Draft recommendations on the review of technical requirements for connection

AEMO Review of technical requirements for connection

Stakeholder: AusNet

Schedule 5.2 Conditions for Connection of Generators

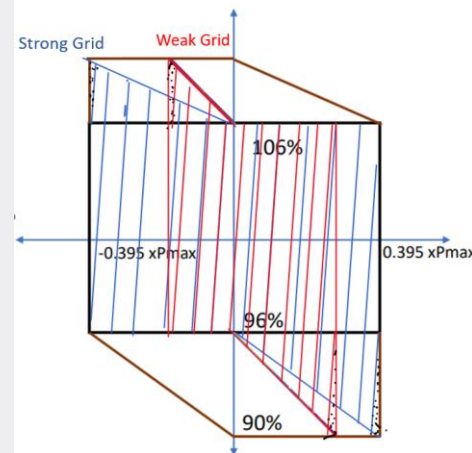
NER Schedule 5.2 issue	Schedule 5.2 (Generators) – feedback on revised recommendations and relevant draft NER amendments
NER S5.2.1 – Outline of requirements	
Application of Schedule 5.2 based on plant type instead of registration category and extension to synchronous condensers	AusNet supports AEMO’s revised recommendation.
NER S5.2.5.1 – Reactive power capability	
Voltage range for full reactive power requirement	<p>AusNet supports AEMO’s revised recommendation in principle. However, for S5.2.5.1 Negotiated access standard c (3), it is suggested to change to the following wording including the voltage-dependent reactive power requirement:</p> <p>“may include negotiate a limit that describes how the <i>reactive power capability</i> varies as a function of active <i>power level</i> or voltage level due to a design characteristic of the <i>plant</i>”</p> <p>AusNet believes that the efficient voltage-dependent reactive power curve should be as follows, which can form a basis for the Negotiated access standard. It can be provided in the assessment guideline or approach paper setting up as a recommended negotiation principle.</p> <ul style="list-style-type: none"> For a key voltage bus node where the voltage is meant to be tightly controlled, the UQ profile similar to the GB grid code (as mentioned in Bo Yin’s response to the Draft Report) utilises plants’ capability more effectively which takes the high dV/dQ sensitivity into account.

- For the bus nodes that are not remote from system strength nodes on the transmission level and are regularly experiencing bidirectional load flow may require more network voltage control support. Under such circumstances, the wider-band UQ profile (e.g., strong grid in the image above) provides more resilience assuming the Q margin (i.e., away from knee point of QV curve) and stability margin (i.e., away from stability limits) are well maintained.
